# Initial Project Review

## Preliminary Plat: The Landing at Spanaway Lake, Phase II

**Application Numbers: 918450, 918451, 918454, 918453**  
**Tax Parcel Numbers: 0319276025 and 0319276026**

**Proposal:** The Applicant is requesting Preliminary Plat approval to subdivide 9.84 acres into 50 single-family lots and dedicate 1.07 acres to open space recreational area. The smallest proposed lot is 4,575 square feet. The largest proposed lot is 13,053 square feet. The average lot size within the plat is 6,371 square feet. All lots would be served by Spanaway Water and Pierce County sanitary sewer. The proposed plat includes three open space tracts:

# THE LANDING AT SPANAWAY LAKE - PH2

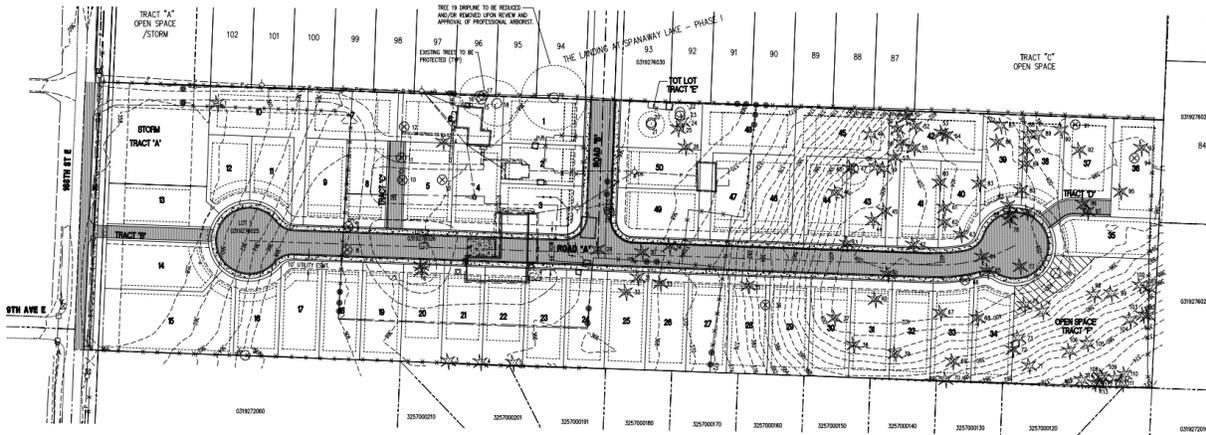
- Resource Management Section of PPW:
  - A Habitat Assessment must be submitted to evaluate the on-site oak trees.
- Current Planning Section of PPW:
  - A tree protection report is requested in accordance with 18J.15.030.

- A tree protection report has been requested in accordance with 18J.15.030. To date, the tree report has not been submitted. Based on the submitted site plan, the applicant is preserving all the trees within the NE corner of the property (Tract F). Proposed Tract “F” is within a sloped area and is within an area that contains the largest concentration of trees on the subject property.
